APPLICATION NO. FILING DATE		FIRST NAMED INVENTOR	ATTORNEY DOCKET NO.	CONFIRMATION NO.	
10/038,264	01/03/2002	Seungbae Park	EN999048D	8328	
7590 01/02/2004			EXAMINER		
David L. Banr		GARCIA, ERNESTO			
Press Building - 19 Chenango St		ART UNIT	PAPER NUMBER		
Binghamton, NY 13901			3679		
			DATE MAILED: 01/02/2004

_		u'				
			Application No.	Applicant(s)	1				
Office Action Summary		10/038,264	PARK ET AL.	•					
			Examiner	Art Unit					
			Ernesto Garcia	3679					
The MAILING DATE of this communication appears on the cover sheet with the correspondence address Period for Reply									
A SHORTENED STATUTORY PERIOD FOR REPLY IS SET TO EXPIRE 3 MONTH(S) FROM THE MAILING DATE OF THIS COMMUNICATION. - Extensions of time may be available under the provisions of 37 CFR 1.136(a). In no event, however, may a reply be timely filed after SIX (6) MONTHS from the mailing date of this communication. - If the period for reply specified above is less than thirty (30) days, a reply within the statutory minimum of thirty (30) days will be considered timely. - If NO period for reply is specified above, the maximum statutory period will apply and will expire SIX (6) MONTHS from the mailing date o

Attachments: one marked-up copy of applicant's Figure 4; and,

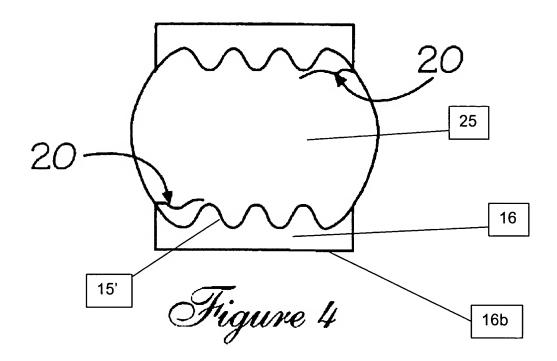
The drawings are objected to as failing to comply with 37 CFR 1.84(p)(4) because reference character "15" has been used to designate both a planar intermetallic boundary (Figure 2) and a non-planar intermetallic boundary (Figure 4); and reference character "10" has been used to designate a pad having a rectangular cross section (Figure 1) and a pad having a non-rectangular cross-section (Figure 4). Applicant is reminded that the pad in Figure 4 should be referenced as 16, as the pad shown in Figure 3a is used in Figure 4, instead of 10.
